U. S. Nuclear Regulatory Commission	Serial No.	12-485
Attention: Document Control Desk	NSSL/MLC	R0
Washington, DC 20555	Docket No.	50-423
	License No.	NPF-49

DOMINION NUCLEAR CONNECTICUT, INC. MILLSTONE POWER STATION UNIT 3 PROPOSED TECHNICAL SPECIFICATIONS TO ADOPT TSTF-510, "REVISION TO STEAM GENERATOR PROGRAM INSPECTION FREQUENCIES AND TUBE SAMPLE SELECTION," USING THE CONSOLIDATED LINE ITEM IMPROVEMENT PROCESS

Marked-up Technical Specifications Changes

6-17c

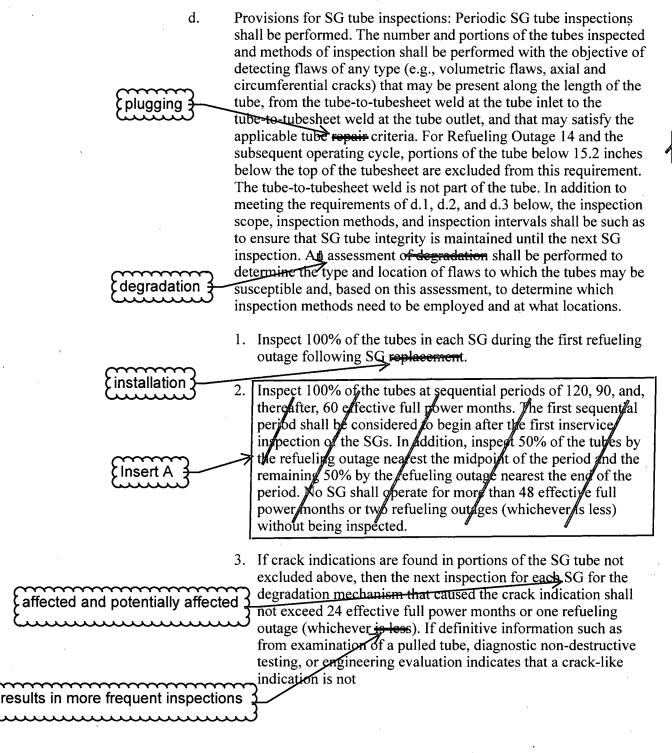
Provisions for SG tube repair criteria: Tubes found by inservice inspection to contain flaws with a depth equal to or exceeding 40% of the nominal tube wall thickness shall be plugged.

The following alternate tube repair criteria shall be applied as an alternative to the 40% depth-based criteria:

For Refueling Outage 14 and the subsequent operating cycle, tubes with service-induced flaws located greater than 15.2 inches below the top of the tubesheet do not require plugging. Tubes with service-induced flaws located in the portion of the tube from the top of the tubesheet to 15.2 inches below the top of the tubesheet shall be plugged upon detection.

plugging

## Insert A for MPS3 TS 6.8.4.g - SG Program (600TT tubes)

- After the first refueling outage following SG installation, inspect each 2. SG at least every 48 effective full power months or at least every other refueling outage (whichever results in more frequent inspections). In addition, the minimum number of tubes inspected at each scheduled inspection shall be the number of tubes in all SGs divided by the number of SG inspection outages scheduled in each inspection period as defined in a, b, and c below. If a degradation assessment indicates the potential for a type of degradation to occur at a location not previously inspected with a technique capable of detecting this type of degradation at this location and that may satisfy the applicable tube plugging criteria, the minimum number of locations inspected with such a capable inspection technique during the remainder of the inspection period may be prorated. The fraction of locations to be inspected for this potential type of degradation at this location at the end of the inspection period shall be no less than the ratio of the number of times the SG is scheduled to be inspected in the inspection period after the determination that a new form of degradation could potentially be occurring at this location divided by the total number of times the SG is scheduled to be inspected in the inspection period. Each inspection period defined below may be extended up to 3 effective full power months to include a SG inspection outage in an inspection period and the subsequent inspection period begins at the conclusion of the included SG inspection outage.

- a) After the first refueling outage following SG installation, inspect 100% of the tubes during the next 120 effective full power months. This constitutes the first inspection period;

- b) During the next 96 effective full power months, inspect 100% of the tubes. This constitutes the second inspection period; and
  - c) During the remaining life of the SGs, inspect 100% of the tubes every 72 effective full power months. This constitutes the third and subsequent inspection periods.
